BID PROJECT NO. 0502-12

ADDENDUM NO.1

**DURAND EASTMAN PARK WATER QUALITY BASIN &
SHERRY SWAMP TRIBUTARY RESTORATION PROJECT**

Date May 22, 2012

SHEET DRAWING NO.
1 OF 1 **GDP-1**

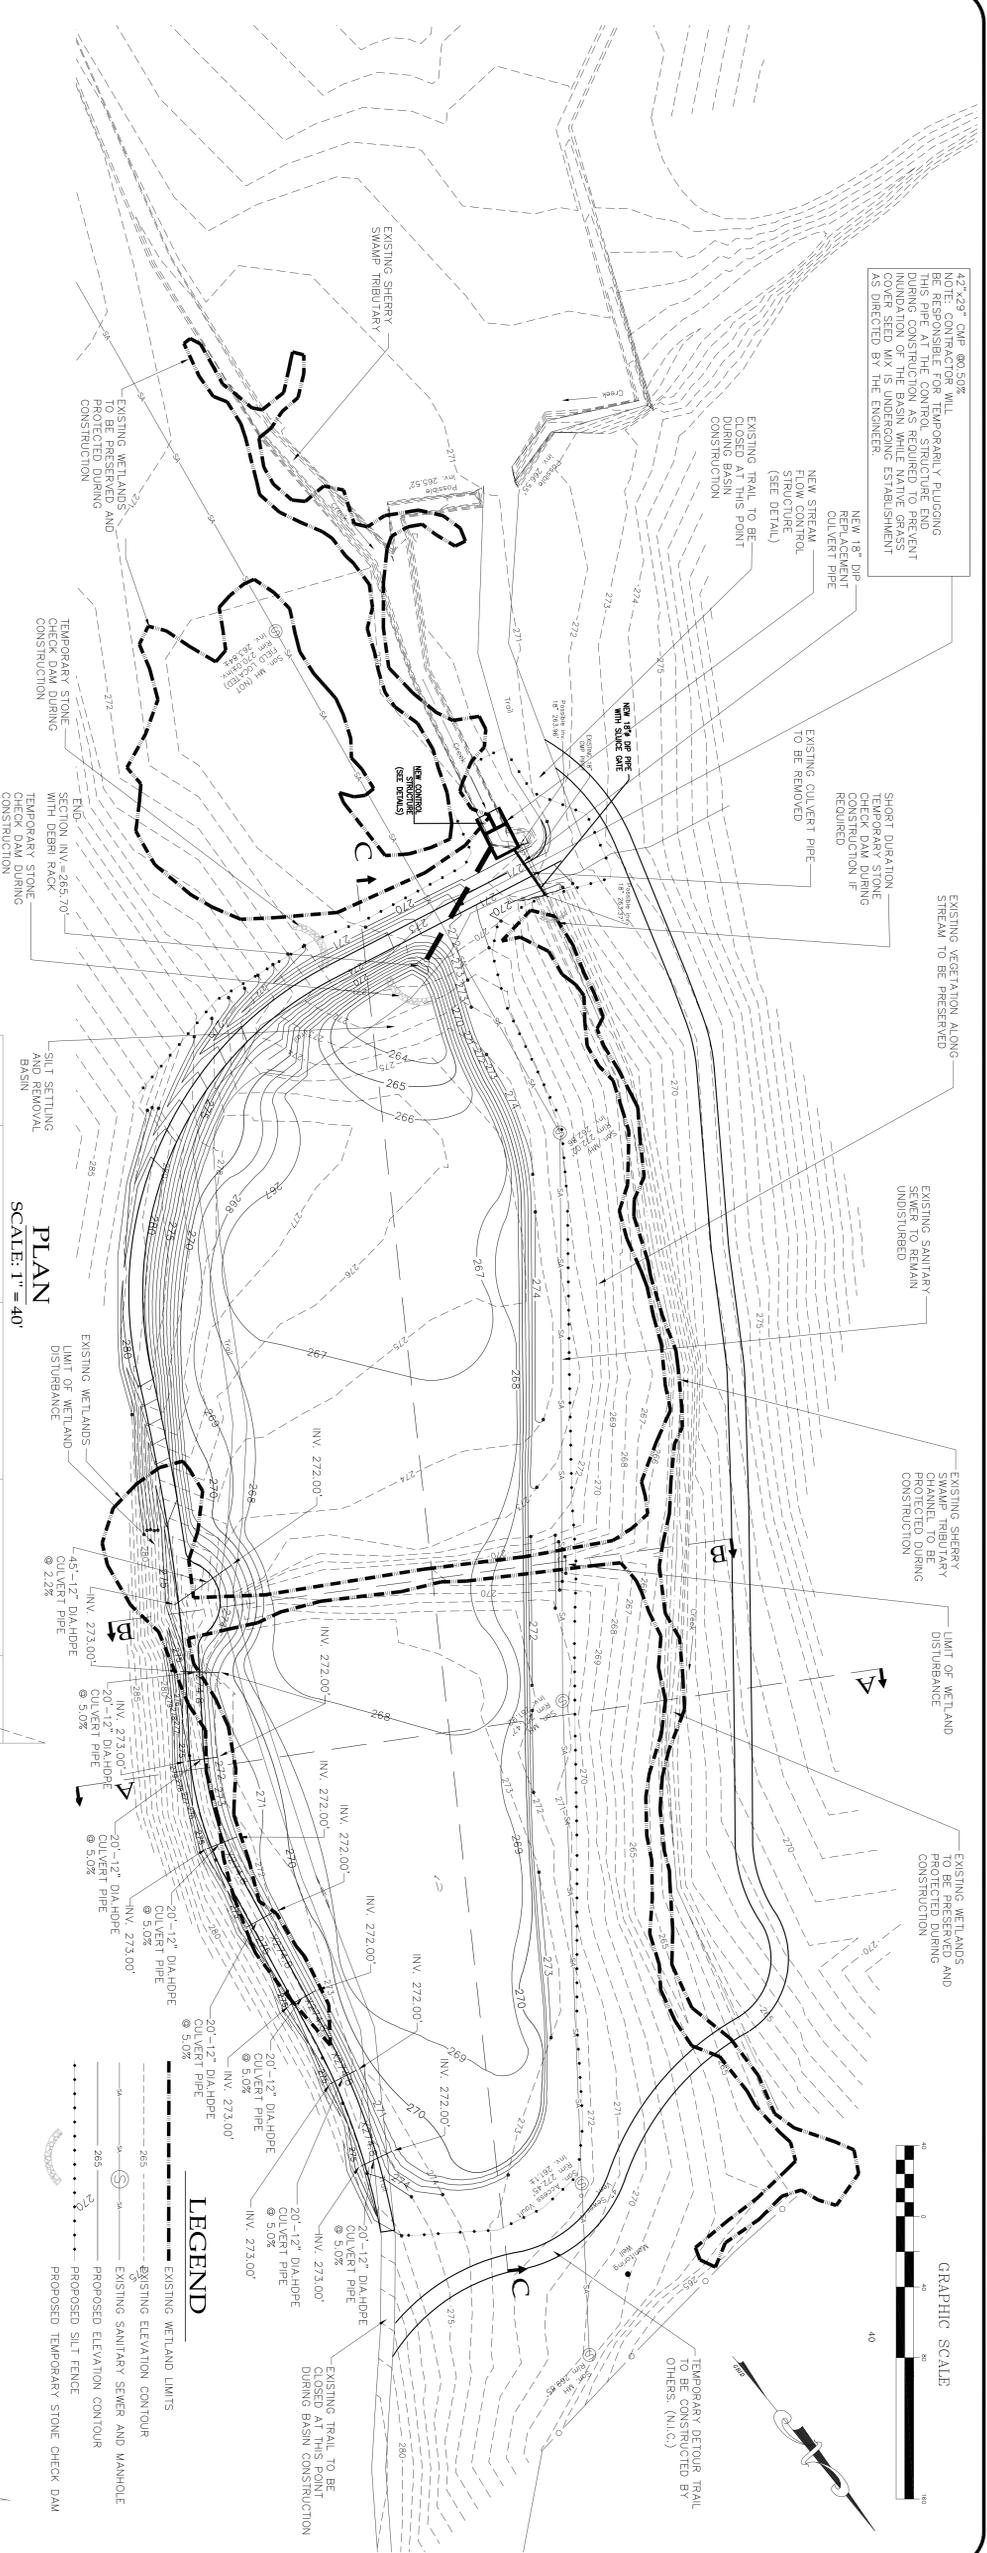
(1-3) Drawing No. GDP-1: Top of western embankment grade elevation revised from 275.00' to 272.00'.

DESIGNED BY: JWH SCALE: 1"=40'
 DRAWN BY: SJW DATE: MAY 2012
 CHECKED BY: JWH PROJECT NO. 0352
 SHEET 1 OF 1 SL-1

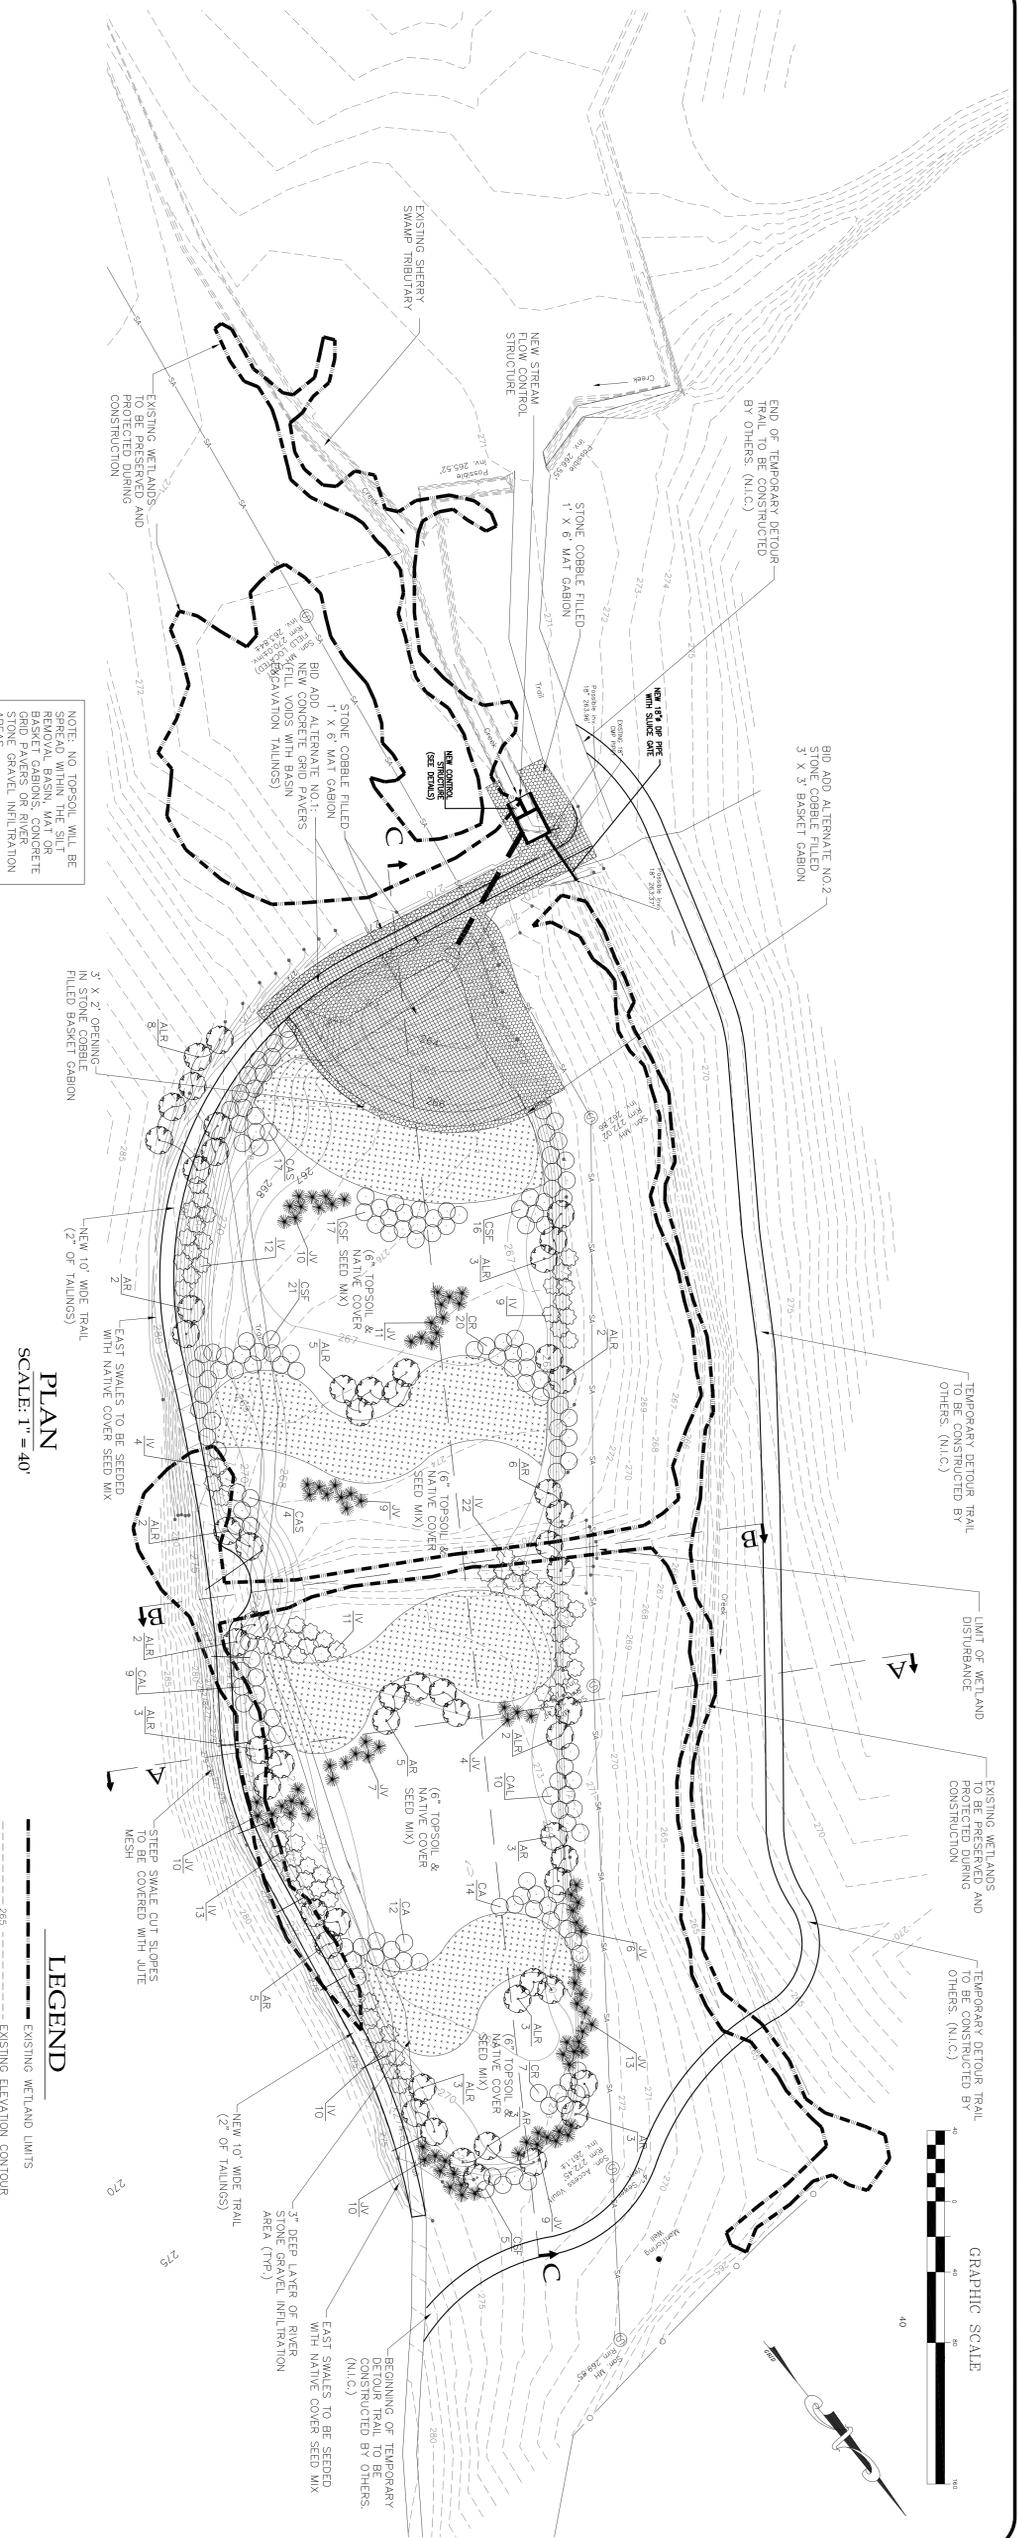
(1-2) Drawing No. SL-1: Top of western embankment grade elevation revised from 275.00' to 272.00'.
